January 7, 2026

Re: Comments and Hearing Request Regarding Lennar Homes of Texas and Jeanette R. Morris and Bobbie J. Neff Application for TPDES Permit No. WQ0016660001- Broken Cedar Ranch Wastewater Treatment Facility

Figure 1: Location of Groundwater Wells from Proposed Broken Cedar Ranch WWTF

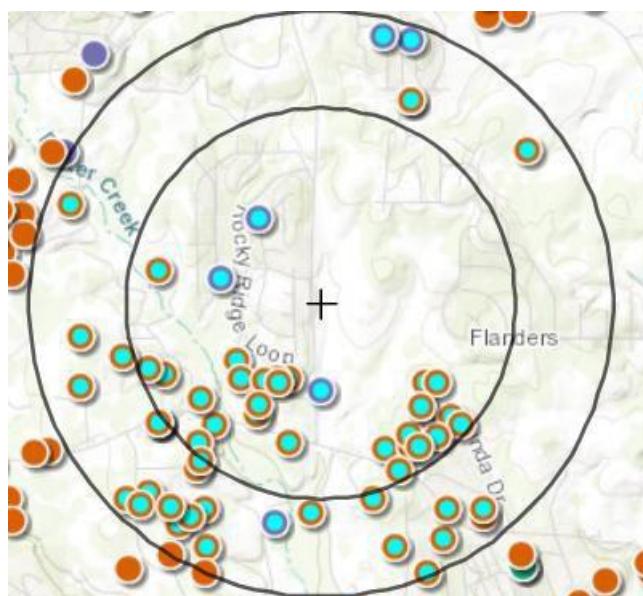
B. Impacts on Surrounding Groundwater Wells and Aquifer Protection: According to the Texas Water Development Board (TWDB), 63 water wells were found to be within a 1.5-mile distance of the Broken Cedar Ranch WWTF, with 32 wells found to be within a mile distance of the Broken Cedar Ranch WWTF (Figure 1). Water well data was pulled from three TWDB groundwater databases: TWDB Groundwater Database (GWDB) reporting 7 wells in the 1.5-mile distance area, Submitted Drillers Reports (SDR) Database reporting 56 wells in the 1.5-mile distance area, and Brackish Resources Aquifer Characterization System (BRACS) Database reporting 0 wells in the 1.5-mile distance area².

Further examining the stated water well data, 56 out of the 63 wells were noted to be used for domestic (household), irrigation, or public supply purposes. The volume of wells located in this close proximity to the facility, discharge point, and route poses a serious concern of cross-contamination with the local groundwater supply that these well owners rely on to meet their needs. Many private wells are not subject to routine water quality monitoring, and well owners rely on groundwater as their primary source of drinking water. The intermittent nature of the receiving stream, combined with the density of nearby wells, raises concerns regarding potential groundwater vulnerability, particularly in areas where

surface water may lose flow to the subsurface.

Additionally, GEAA notes that the application does not include a site-specific evaluation of groundwater connectivity, losing-stream conditions, or well vulnerability along the discharge route. GEAA requests that TCEQ carefully consider the proximity of groundwater resources and ensure that permit conditions adequately protect aquifer resources and private well users.
